# DESIGN ERROR 1

## The construction and arrangement of the duff chute:

### A false premise

The hinge assembly

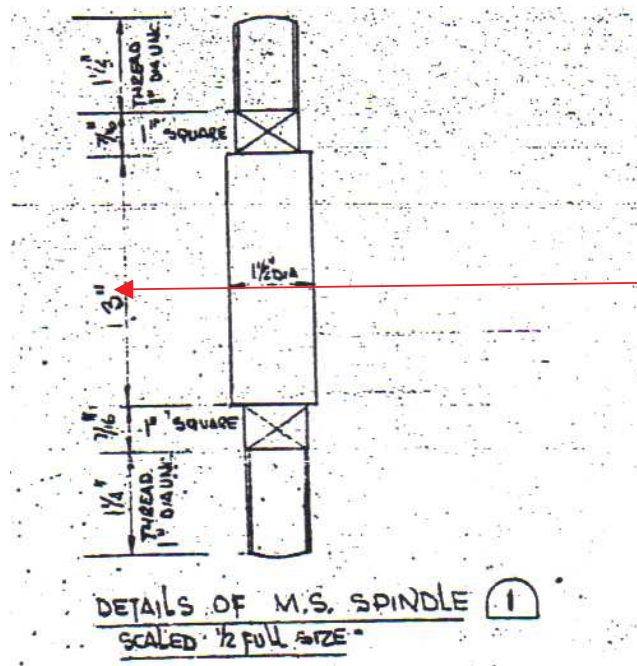
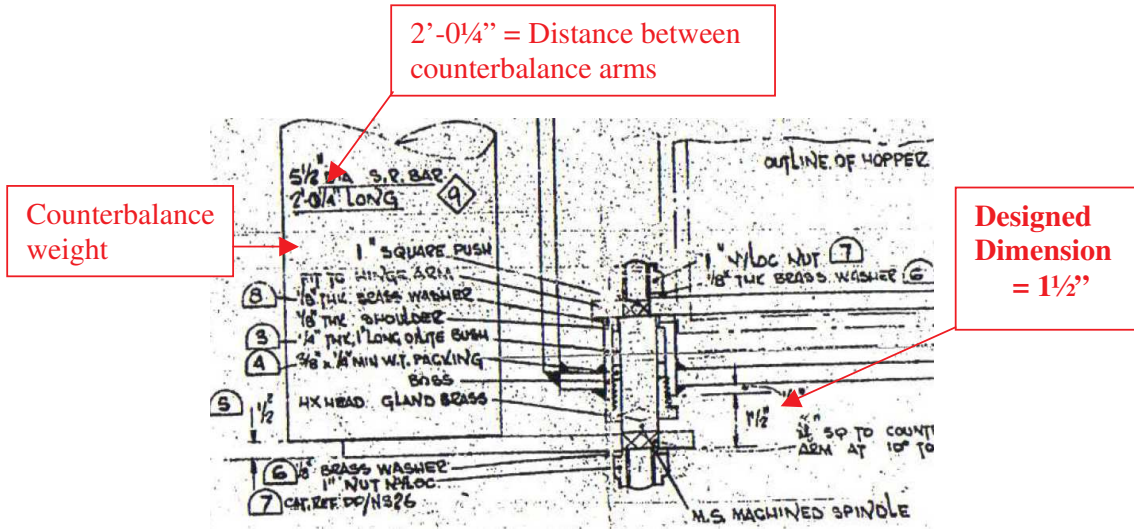
There was a dimensional error on the shipyard’s construction drawing for the duff and offal chute valve flap hinge assembly in that the length of the median portion of the spindle should have been 3¼” instead of only 3”, as the design prescribed. (for further information on this point see the part prints below and Annex 1) this dimensional error only becomes apparent when the distance between the two counterbalance arms (indicated to be 2’-0¼” on the drawing) is matched against the sum of the dimensions of the parts between the counterbalance arms and the position of the hinge spindles, which was fixed. Although the effect of this error would not have appeared as significant at the time of assembly, it would have reduced the clearance between the end of the brass glands and the steel counterbalance arms, making it insufficient.

The fact that this portion of the spindle was indicated as 3” long meant that the **designed dimension** of 1½” between the end of the boss and the outer surface of the counterbalance arm (that is indicated above) could not be achieved in practice. This part of the spindle should, in fact, have been 3¼” long.

### Sketch of the hinge assembly in the duff and offal chute flap valve:

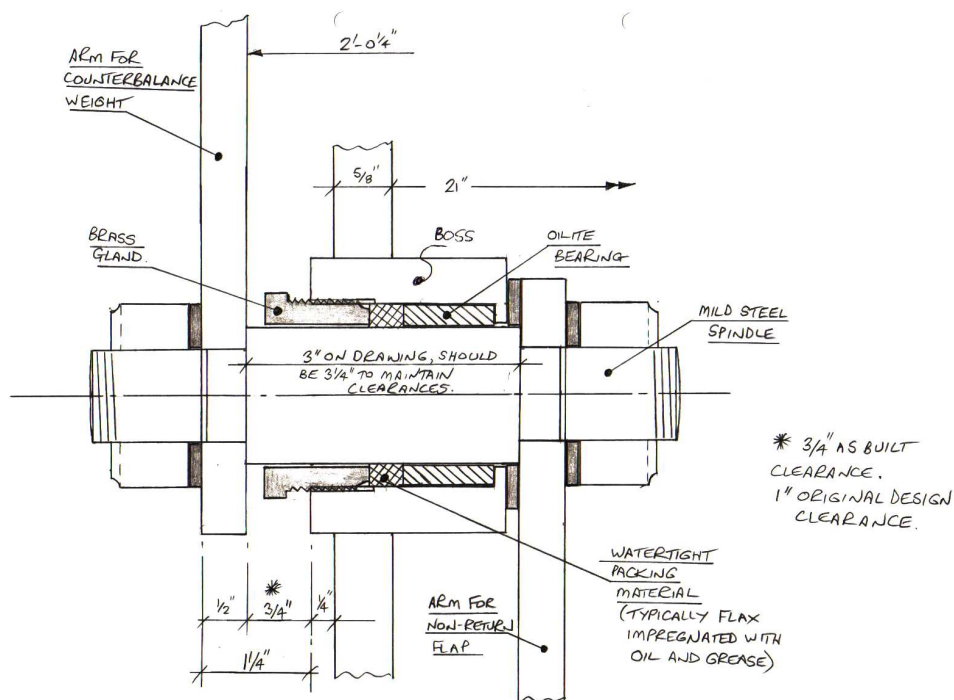
On page 2, partial copies of the flap valve hinge drawing are shown, on those copies three dimensions are indicated which are incompatible (the 3" dimension indicated on the M.S. spindle is obviously an error). The hinge has been redrawn below and it may be seen that the clearance between the end of the boss (and brass gland) and the counterbalance arm has been reduced by  $\frac{1}{4}$ ".

With the clearance as originally designed, the brass gland would be capable of being fully unscrewed without contacting the counterbalance arm. However, the error in the spindle dimension has meant that the clearance has been reduced such that if the brass gland were unscrewed it would come into contact with the arm while the threaded portion of the gland remained in the thread of the boss.

\*The dimension marked with an asterisk in this drawing ( $\frac{3}{4}$ " ) is fixed by the dimensions of the steel spindle. This dimension should have been 1".
